REVISED RESPONSE TO REQUEST FOR ADDITIONAL INFORMATION

APR1400 Design Certification

Docket No. 52-046

RAI No.: 253-8300
SRP Section: 03.07.01 – Seismic Design Parameters
Application Section: 3.7.1
Date of RAI Issue: 10/19/2015

Figure 3.7A-13 Comparison of Design Time History Compatible with CSDRS with Site Response Motion at Foundation Base Elevation of Seismic Category I Structures, N-S Motion, 5% damping

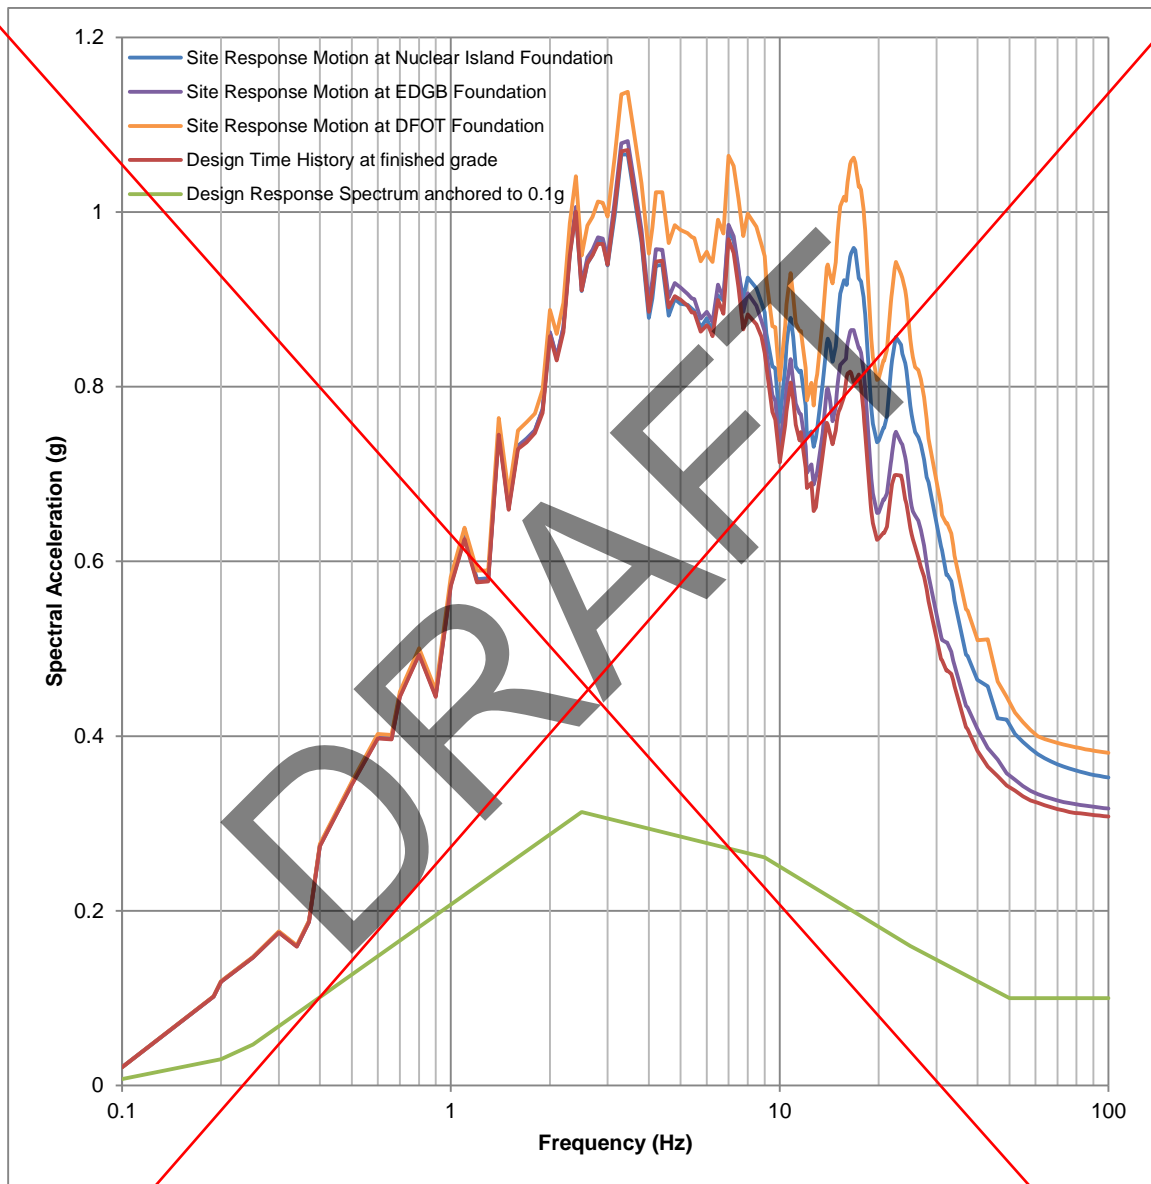
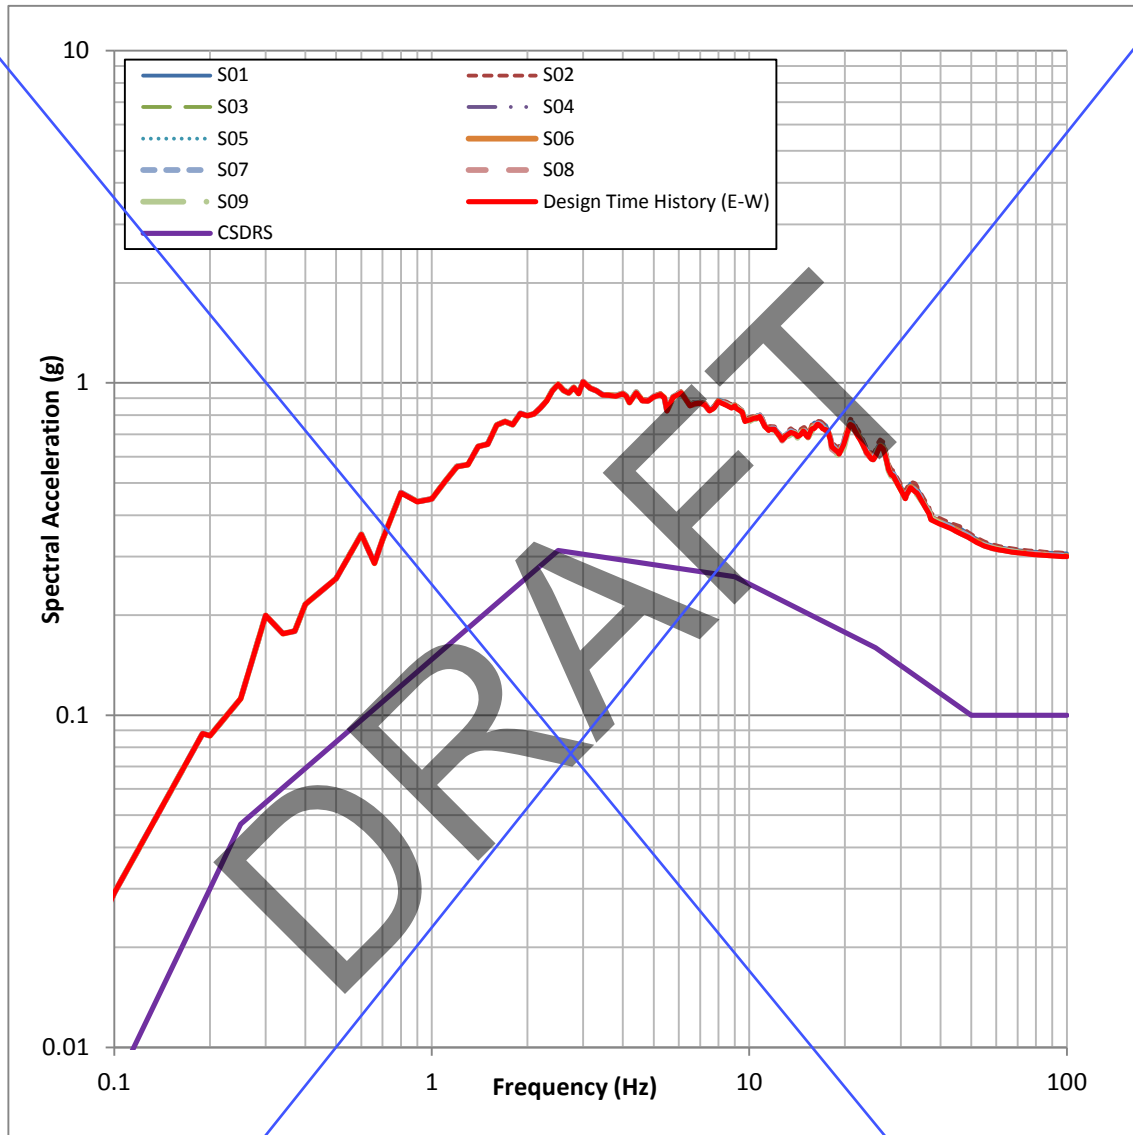
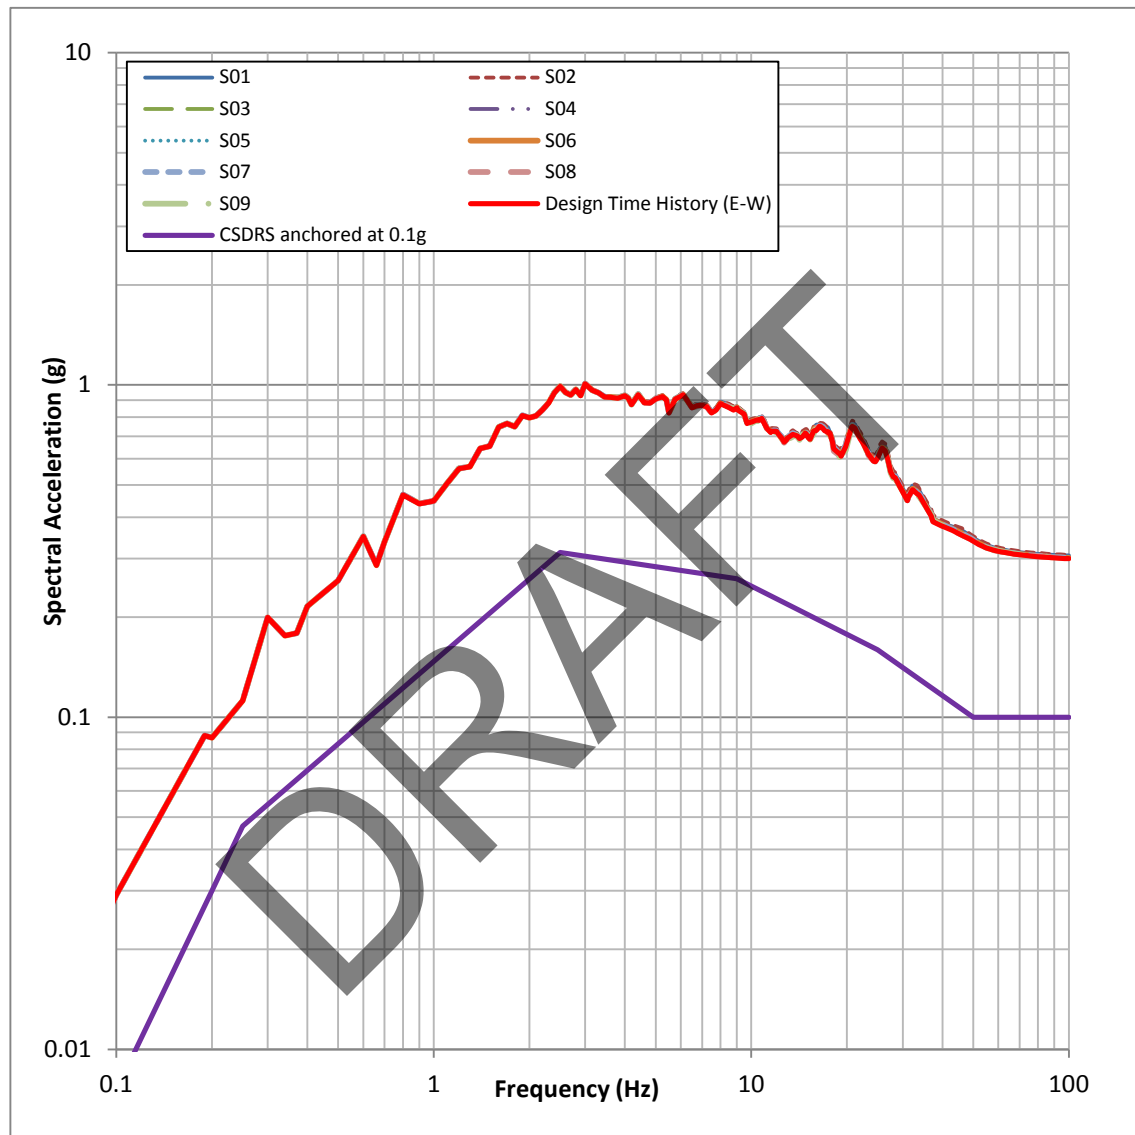
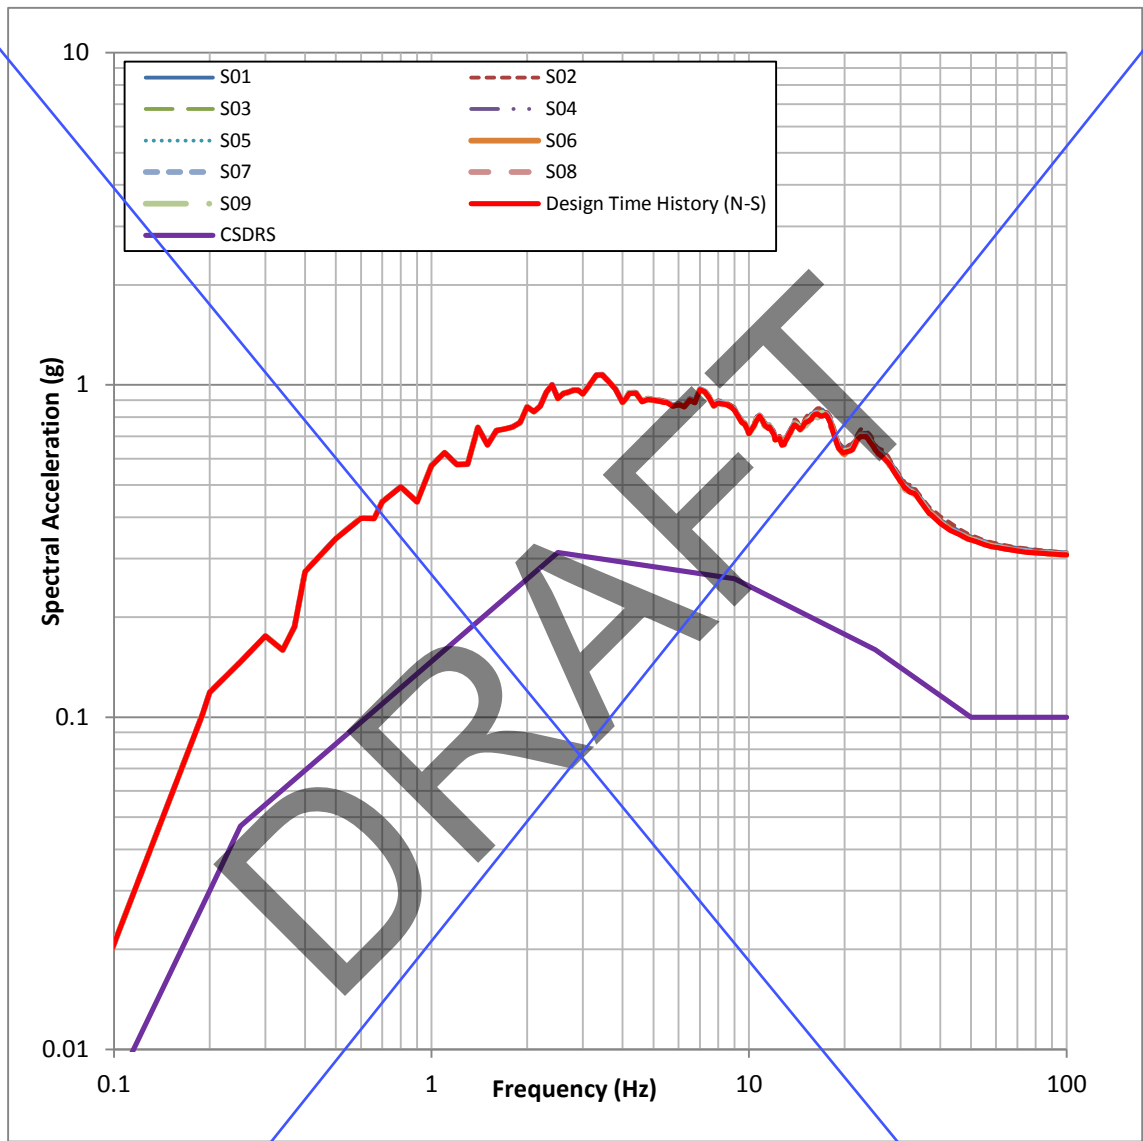
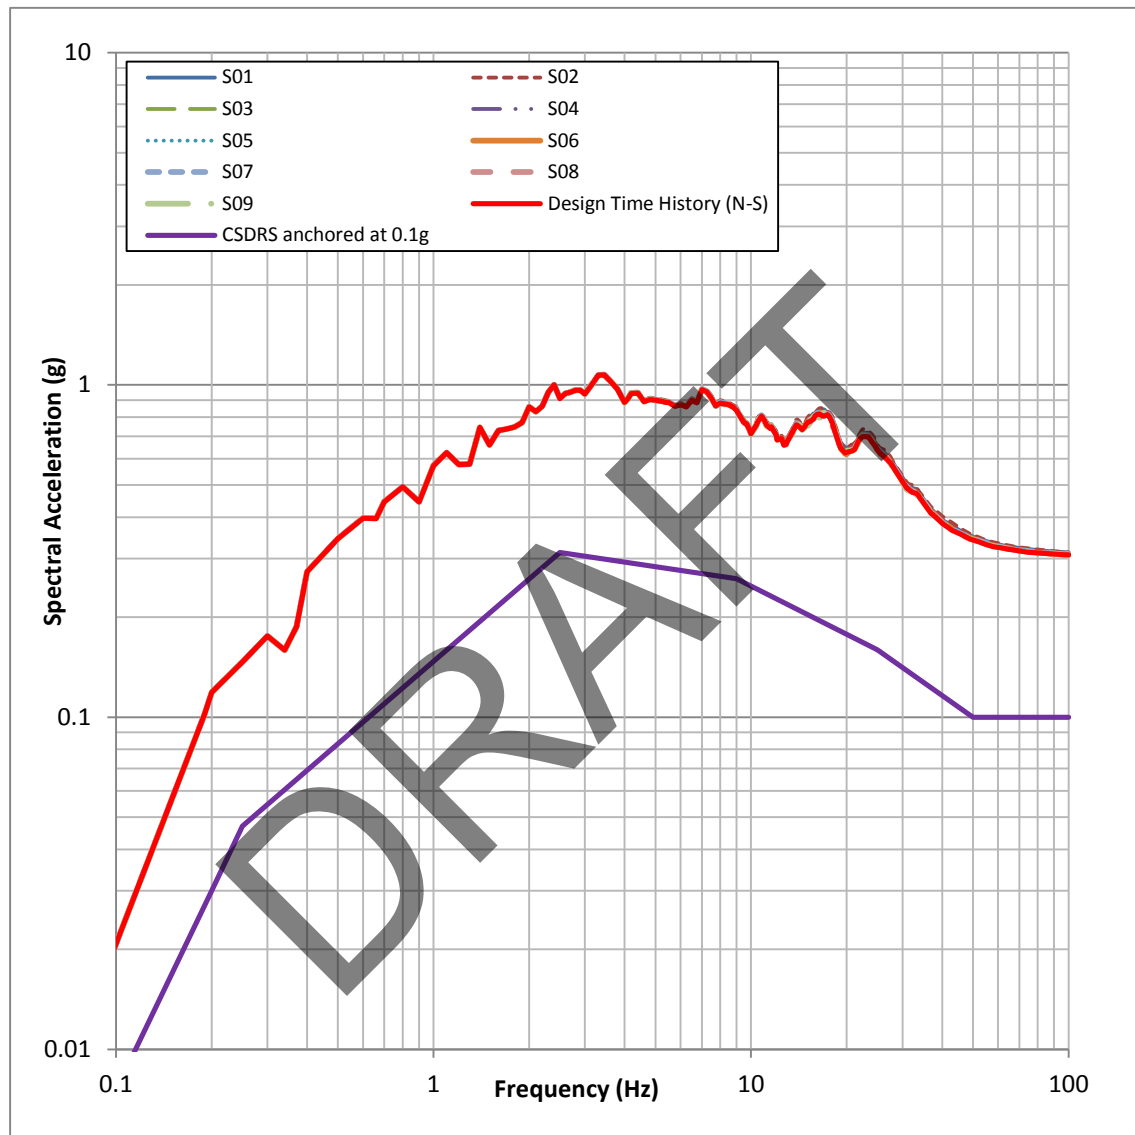
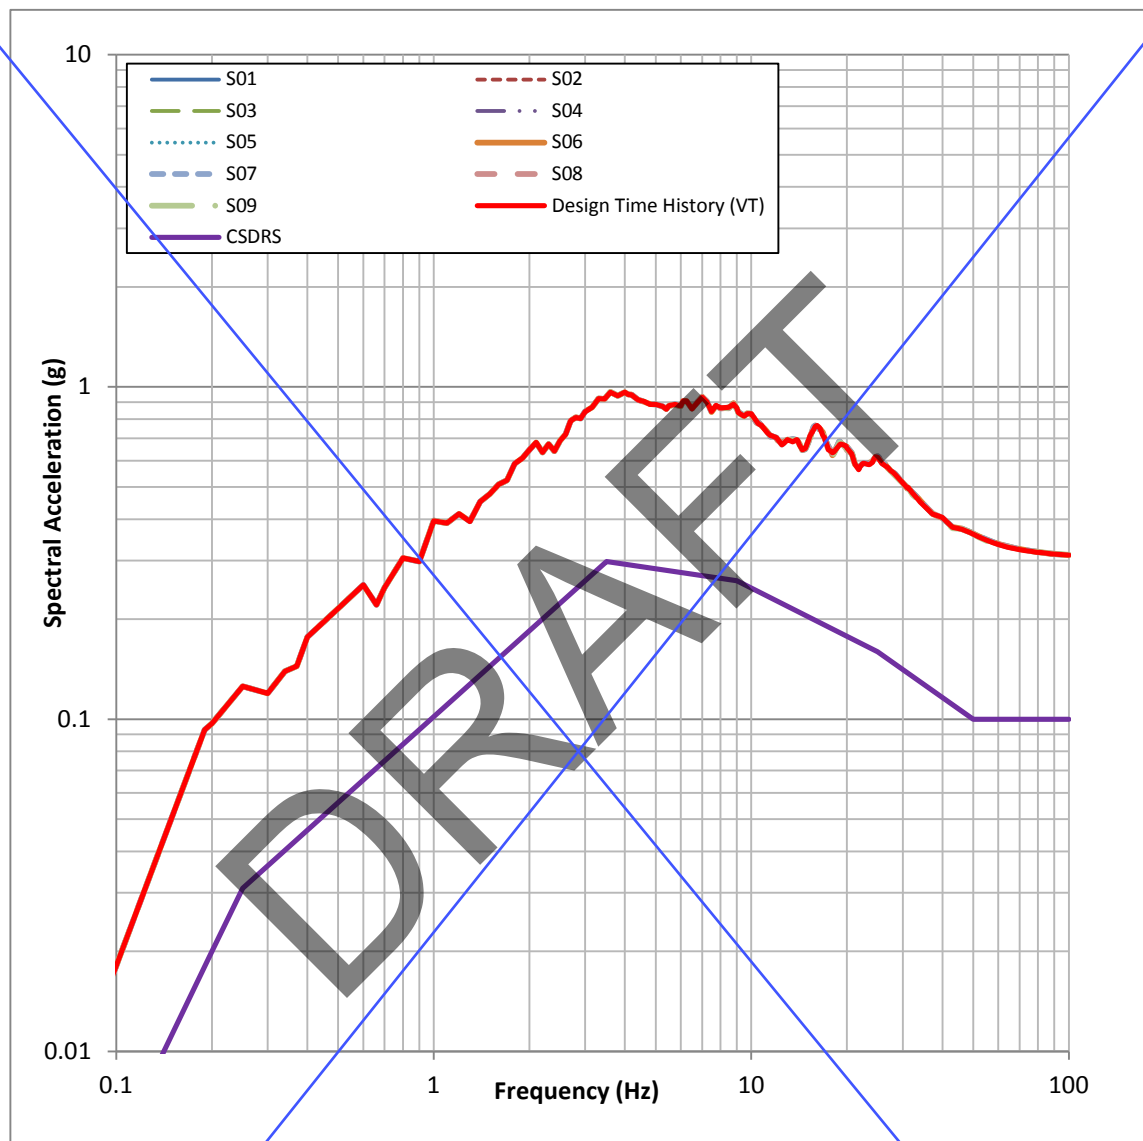
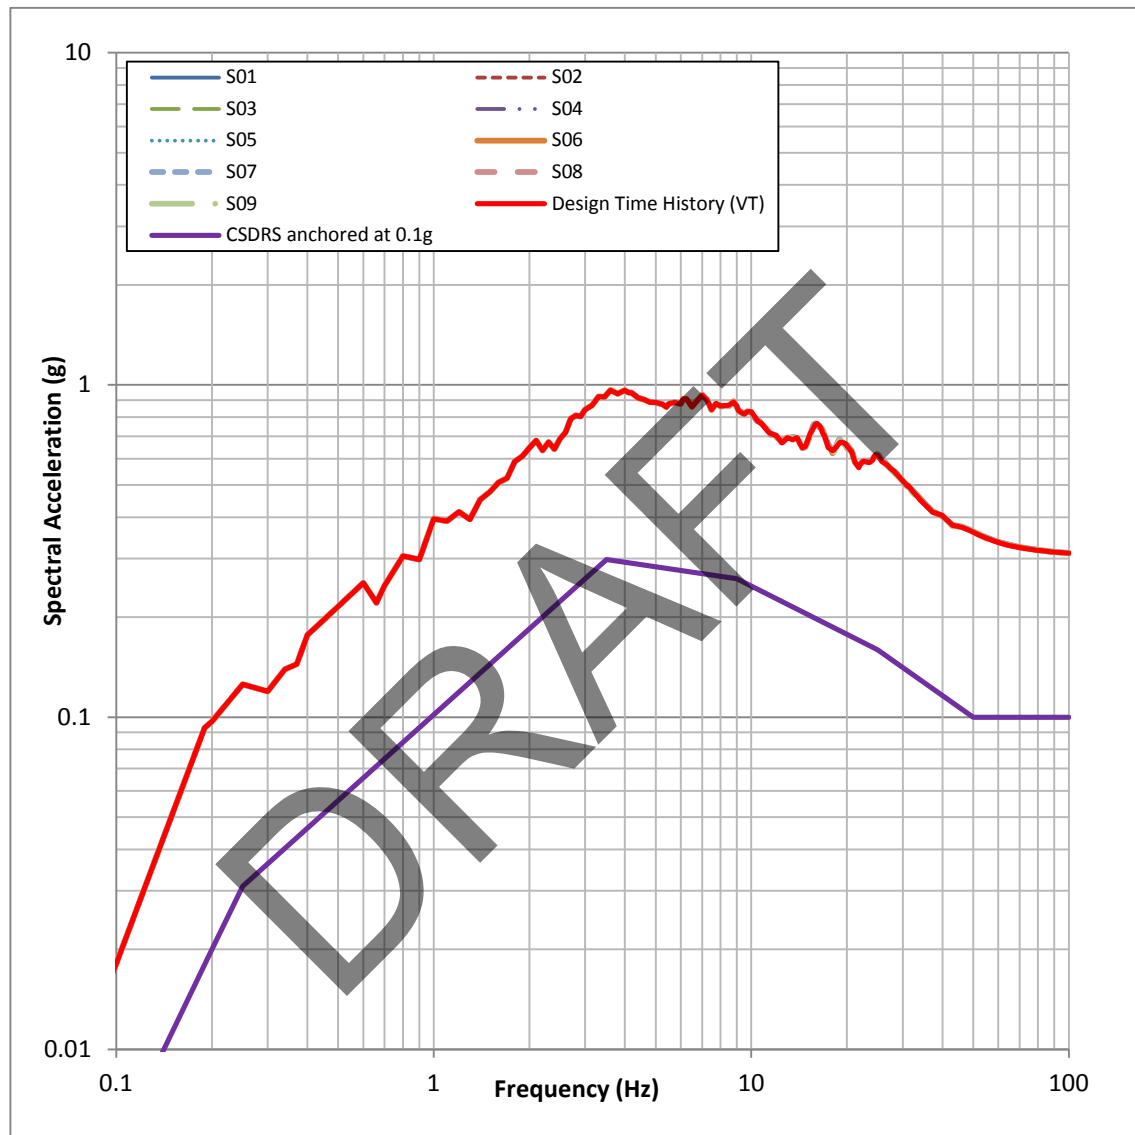
[NOTE: In supplementing Figures 3.7A-12 and 3.7A-13, figures should be provided separately for each building; otherwise the figures would be too crowded. In addition, the curves should be rendered with different line styles/weights, in addition to different colors, to accommodate black-and-white copying.]

ii) The CSDRS are defined in DCD Section 3.7.1.1.1 as linearly interpolated on a log-log scale between the control points. The CSDRS scaled to 0.1g in Figures 3.7A-12, 3.7A-13, and 3.7A-14 are not correct because they are interpolated on a log-linear scale. Therefore, the CSDRS scaled to 0.1g should be corrected in Figures 3.7A-12 through 3.7A-14 of the DCD.

iii) Some of the labels in Figures 3.7A-12 and 3.7A-13 do not appear to be in the correct order. For example, labels for EDGB and DFOT appear to be switched in Figure 3.7A-12, and the labels for NI, EDGB, and DFOT seemingly should be EDGB, DFOT, and NI, respectively, in Figure 3.7A-13 (based on comparison to Figures 5-25 through 5-31 in APR1400-E-S-NR-14001-P, Rev. 0). In this report, Figure 5-26 appears to be exactly the same as Figure 5-25. The applicant is requested to correct these incorrect labels and figures in the DCD and report.

- a) Figures 3.7A-12, 3.7A-13, and 3.7A-14 in DCD Tier 2 and Figures 5-25 through 5-31 in APR1400-E-S-NR-14001-P/NP, Rev.0, "Seismic Design Bases" will be revised as indicated in the attachment associated with this response. The revised figures are presented on a log-log scale. Labels on the revised figures, along with those which have not been changed in the DCD and technical reports, have been reviewed and confirmed to be correct. DCD Tier 2, Section 3.7.6 cites ARP1400-E-S-NR-14001-P/NP, Rev.0, "Seismic Design Bases" as Reference 9.
- b) The $CSDRS_{ff}$ is generated from outcrop motions using the SHAKE91 program. The outcrop motions are calculated at the foundation elevation of each building. The procedure described in the NEI white paper, "Consistent Site-Response/Soil-Structure Interaction Analysis and Evaluation," (June 12, 2009) was followed to produce the results.
